DSO9404A-01 <u>S E R V I C E N O T E</u>

DSO9404A 4 GHz Digitizing Oscilloscope

Serial Numbers: MY49190102 and MY49190103

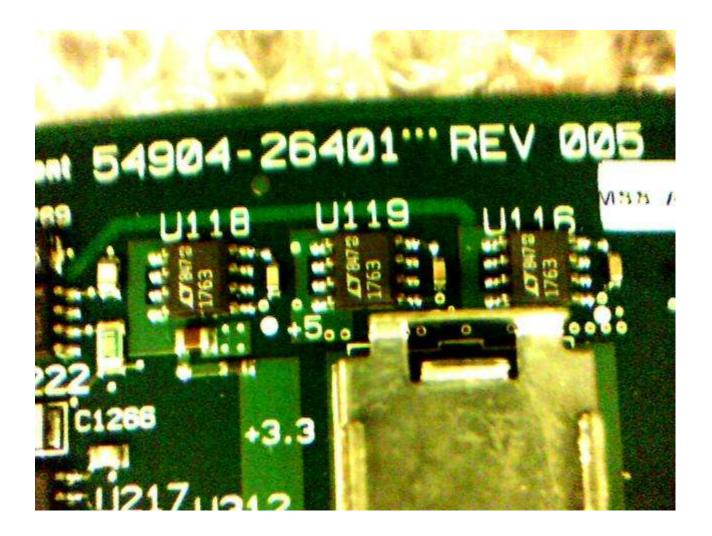
This is a onetime replacement because you are replacing the acquisition board 54901-66501 rev 005 with a later board rev of at least 006. The below picture shows a typical board number with the board rev listed. The board number 5490X-26401 is the raw PC board number. Once the board is loaded with parts and tested, the board number changes to 5490X-66501. The important part of the below picture is that the board rev of 005 is shown. This board must be removed from the scope and returned to SPO. SPO will return the defective board to AMC. You can install a new or refurbished acquisition board in the scope. At the writing of this service note, the new board part number was 54904-66501 and the refurbished part number was 54904-69501. If the board rev is 006 or higher, do not replace the acquisition board with this service note.

Refer to the 9000 series service manual for instructions to remove and replace the acquisition board. Perform the self calibration and self tests to make sure the replacement board is functioning correctly. Run final calibration on the scope and issue a new certificate of calibration. Charge the replacement acquisition board, labor, and calibration time to factory warranty.
